P&Z CASE # SP2021-018 P&Z DATE 07/13/21 CC DATE _____ APPROVED/DENIED _____

PROJECT NUMBER: SP2021-018
PROJECT NAME: Site Plan for Lakeshore Office Building
SITE ADDRESS/LOCATIONS: 1942 N LAKESHORE DR

06/25/2021: SP2021-018; Site Plan for a Lots 2 & 4, Block A, North Lake Shore Daycare Addition
Please address the following comments (M= Mandatory Comments; I = Informational Comments)

REDESIGNED SITE PLAN
OFFICE BUILDING
 NEC OF N. LAKESHORE DRIVE & E. FORK ROAD
 CITY OF ROCKWALL
 ROCKWALL COUNTY, TEXAS

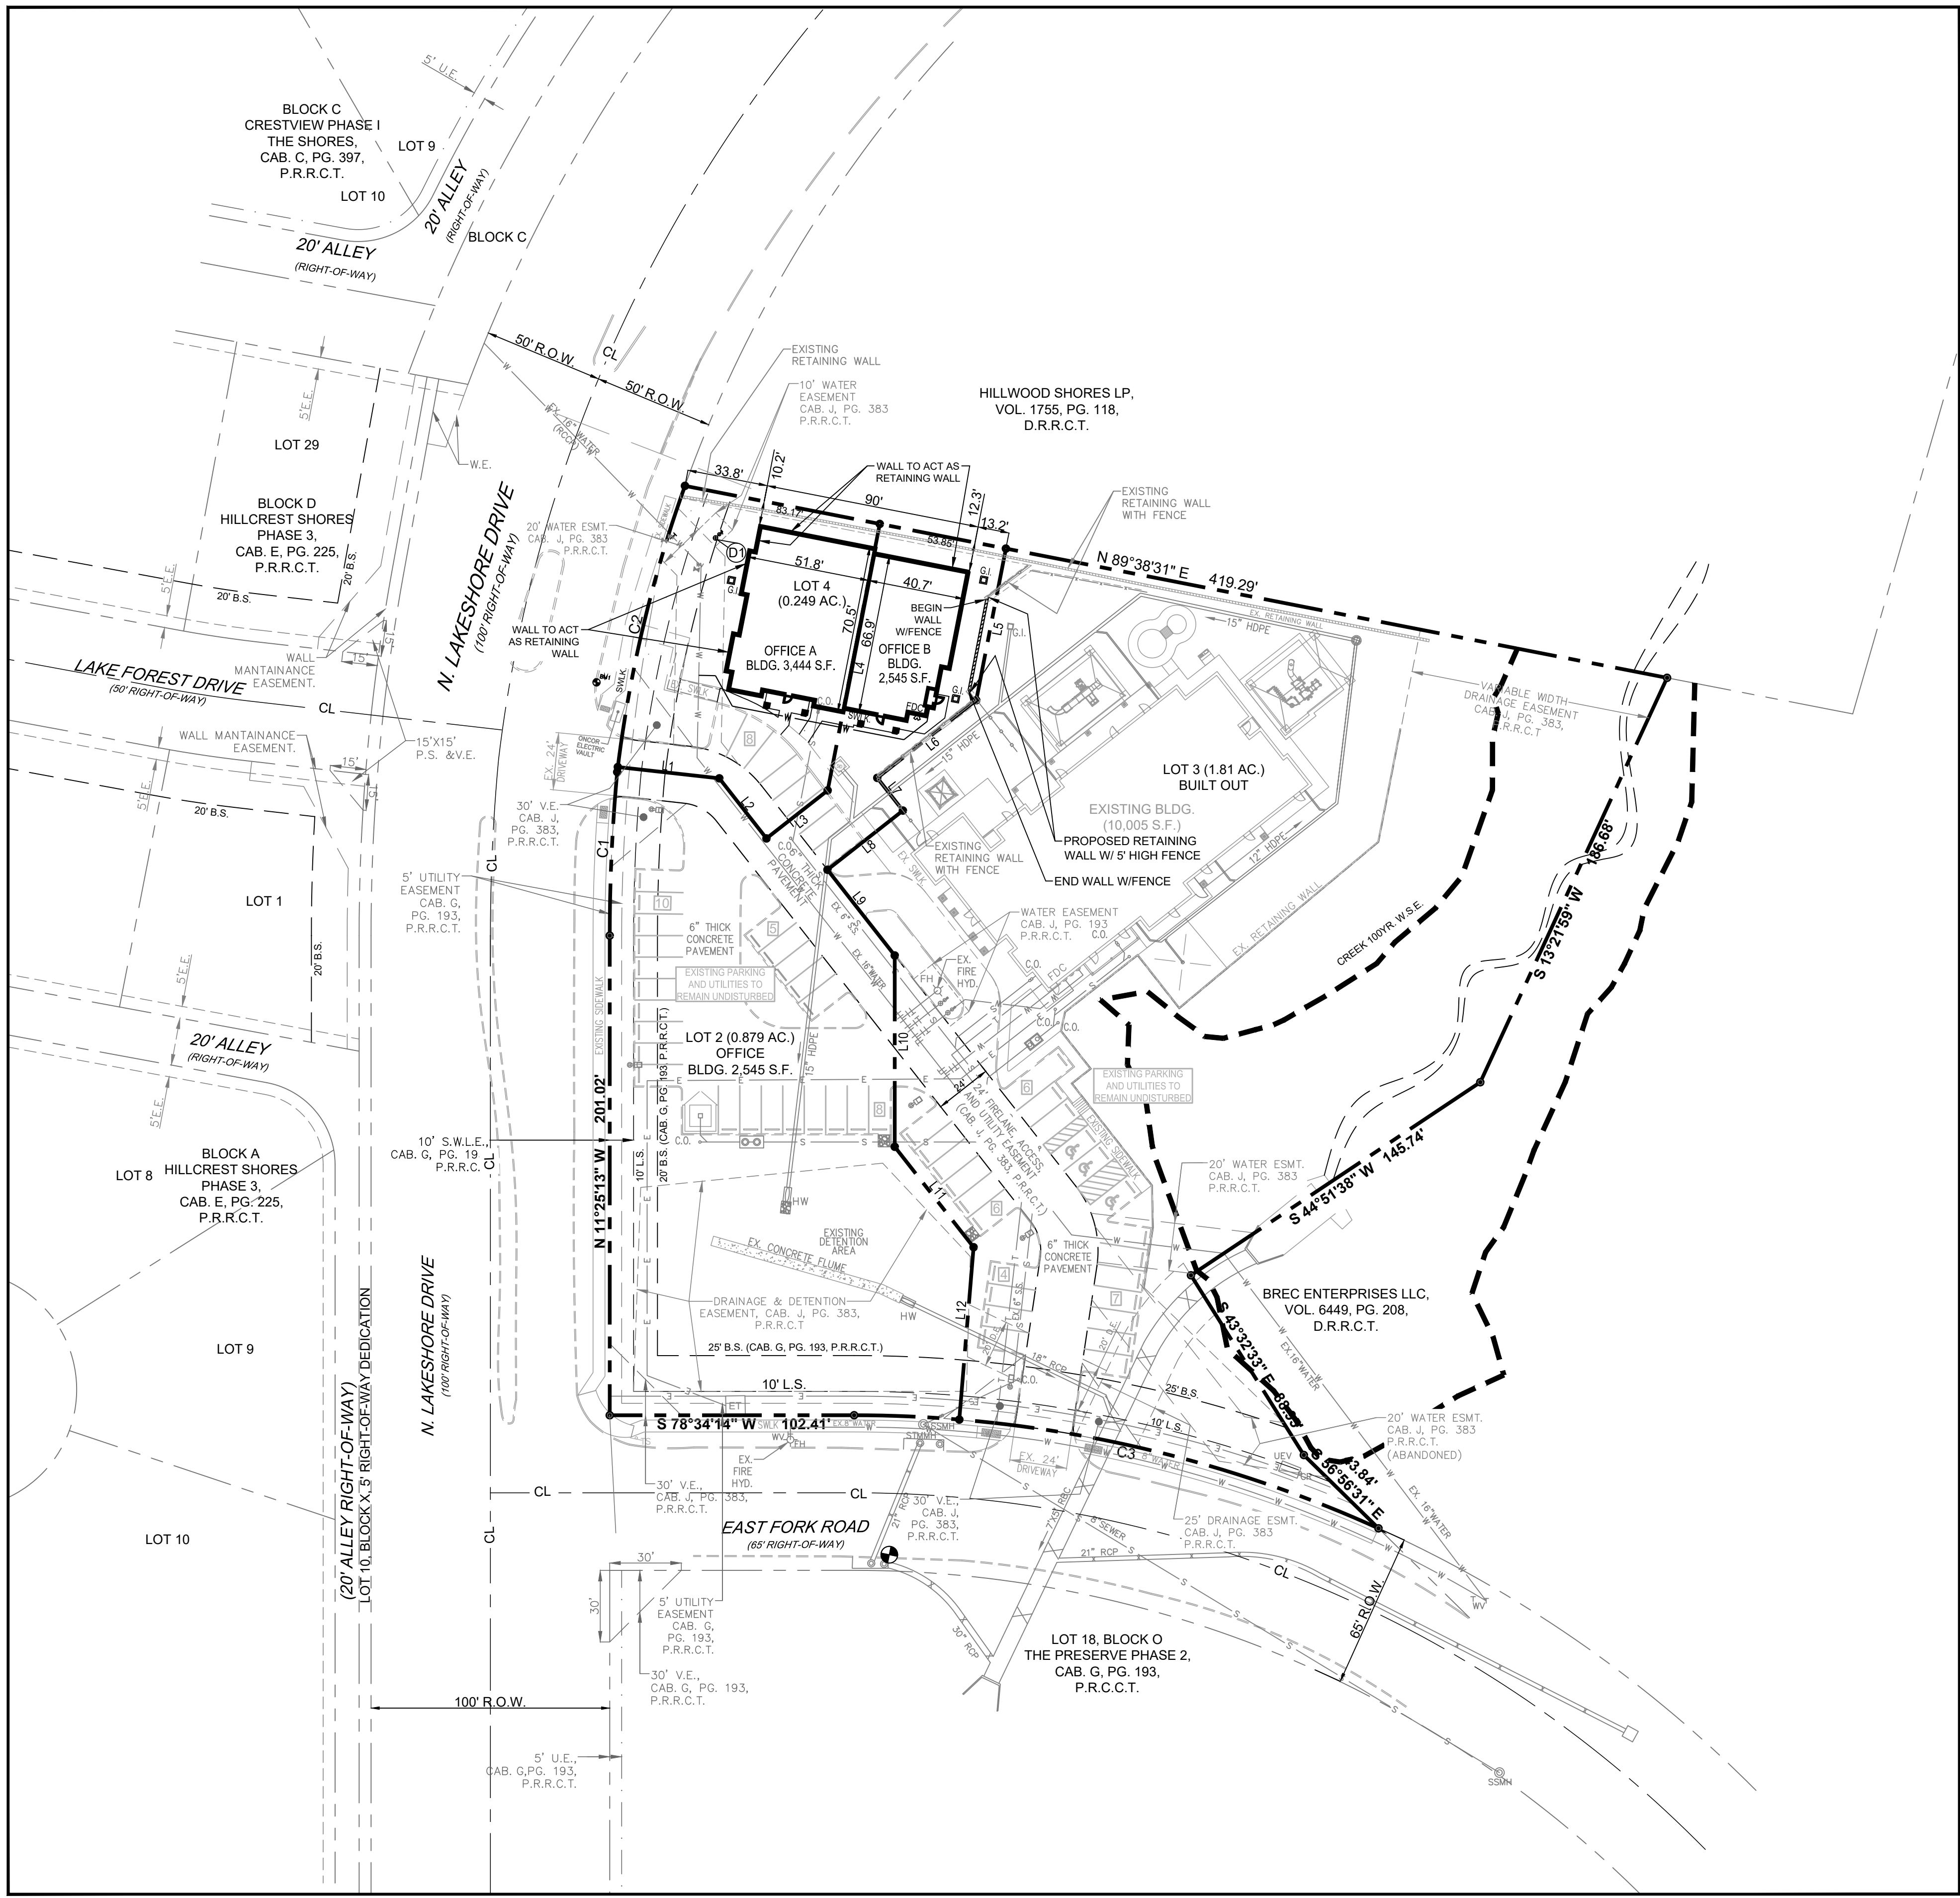
M.9 Site Plan. Please make the following clarifications on the site plan to ensure staff can properly review this project and convey all of the required elements to the City's boards

- 1) Mechanical Equipment Screening. Are the units on the ground or on the roof? If on roof, dash-in RTU's or indicate on building elevations. If ground mounted, indicate locations on site and provide screening detail - All buildings shall be designed so that no HVAC, satellite dishes, appurtenances and/or any other mechanical equipment visible from any direction. This shall include equipment located on the roof, on the ground, or otherwise attached to the building or located on the site? Provide screening detail. (§06.02.C.3, of Art. 05, UDC)

- 2) Remove the 'R.O.W Dedication' label from the Site Data Summary Table if not dedicating ROW. If dedicating, hatch and label area to be dedicated.
- 3) Will there be a trash dumpster for the subject property? If so, enclosures shall be four (4) sided, shall be screened by a minimum eight (8) foot, solid masonry dumpster enclosure that utilizes the same masonry materials as the primary building and incorporates an opaque, self-latching gate. Provide detail. (§06.02.D.7, Art. 05,UDC)

EXTERIOR ELEVATIONS
A3.1

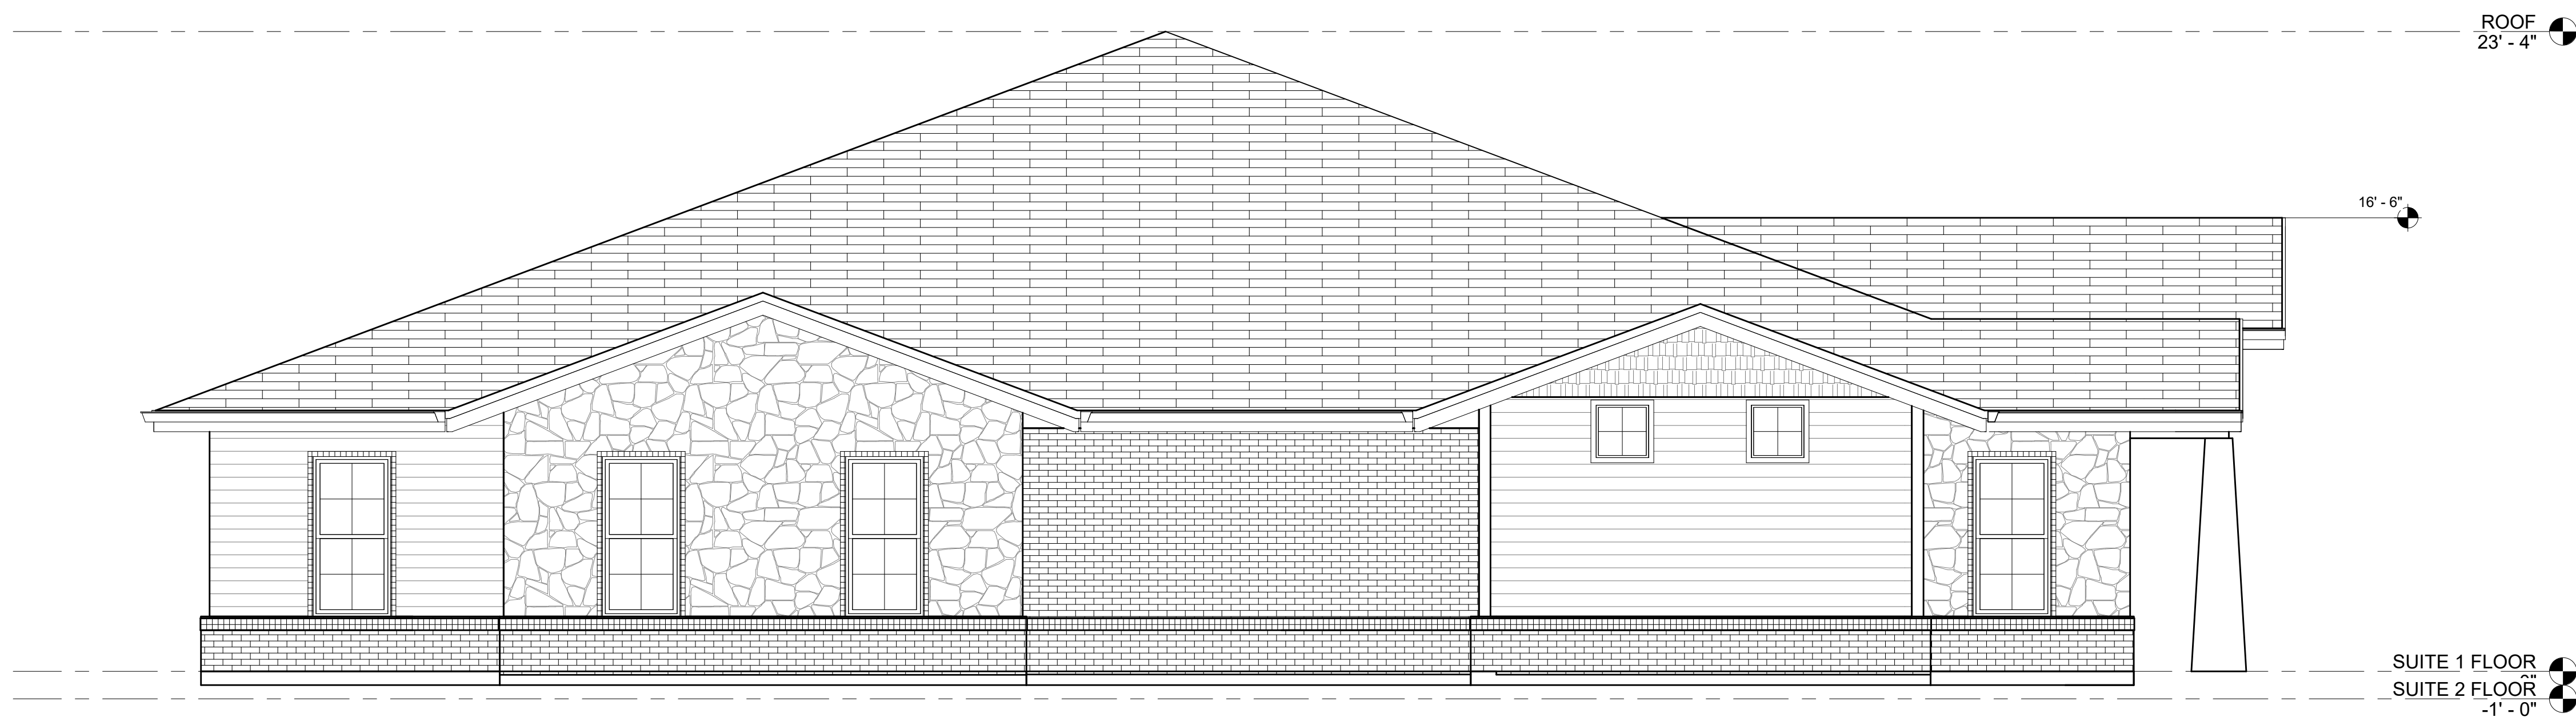
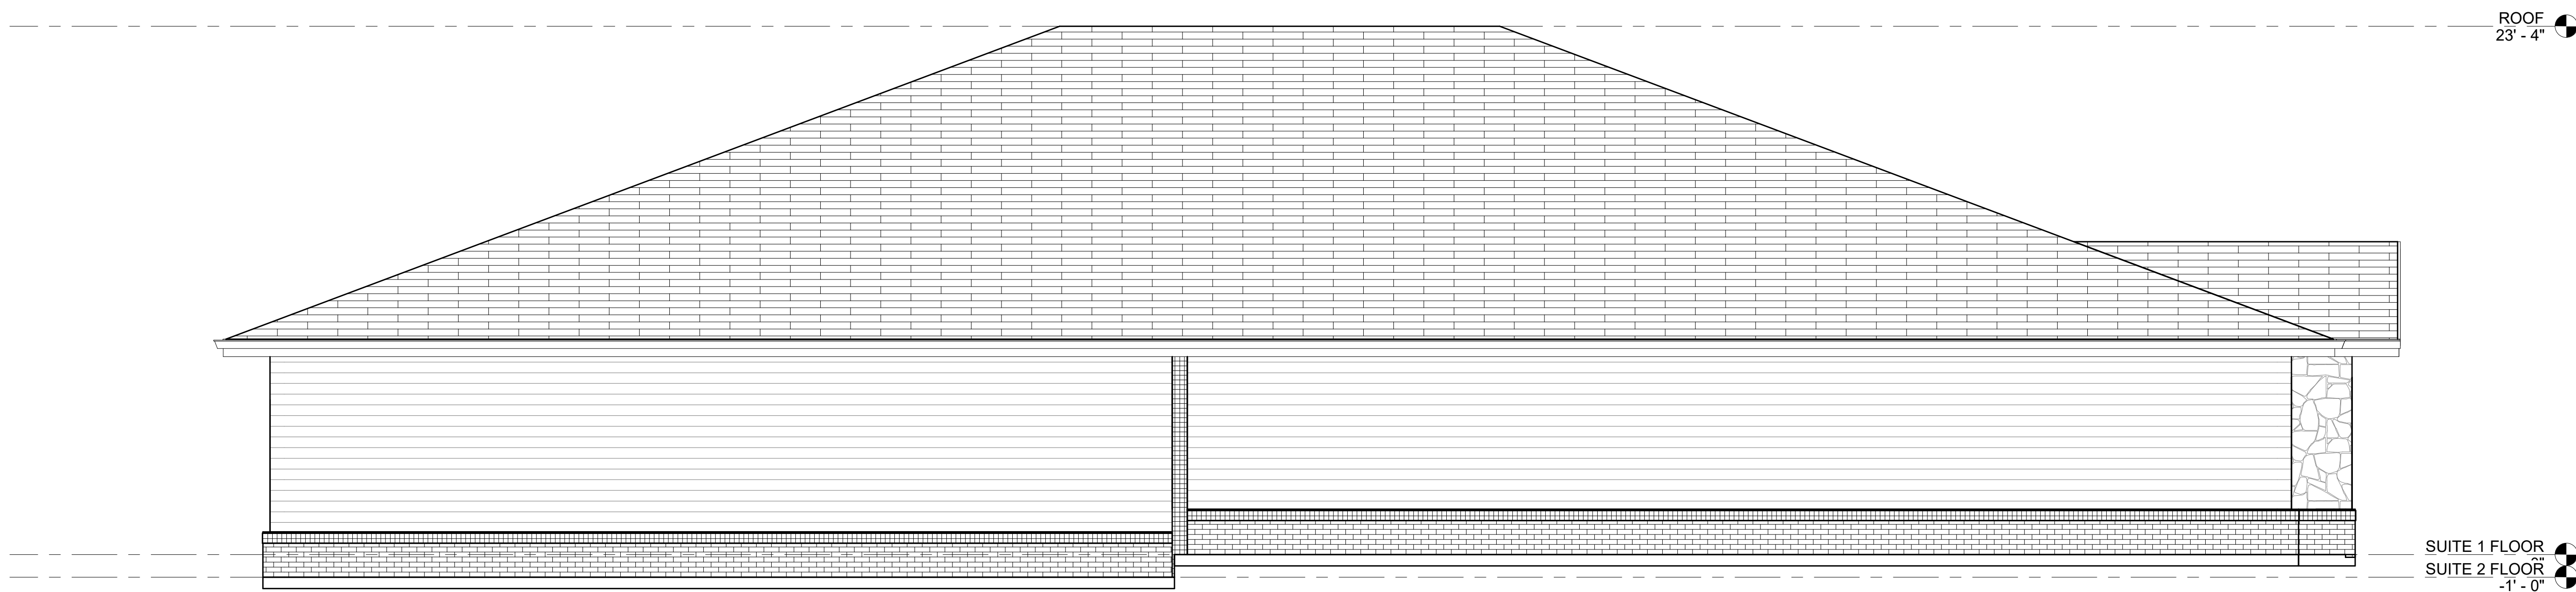
M.13 Building Elevations. Requires review by the Architectural Review Board (ARB) and a recommendation from the ARB forwarded to the Planning and Zoning Commission for consideration.

- 1) Recalculate exterior materials for each façade by removing the calculation for the roof shingles. Additionally, are these architectural roof shingle? (§06.02.C.1.a.3.a, Art. 05,UDC)
- 2) Exterior Material Samples Board (MSB) is required for Architectural Review Board (ARB) review. Provide an MSB prior to the ARB meeting to be held on June 29, 2021. (§03.04.A, Art. 11, UDC)

- 1) Building Articulation – As depicted, the building elevations do not meet the articulation standards as required in Figure 7 of Subsection 04.01.C, of Article 05, of the UDC for the following: (§04.01.C, Art. 05,UDC)
 - a. Wall projections (i.e. horizontal articulation – north elevation)
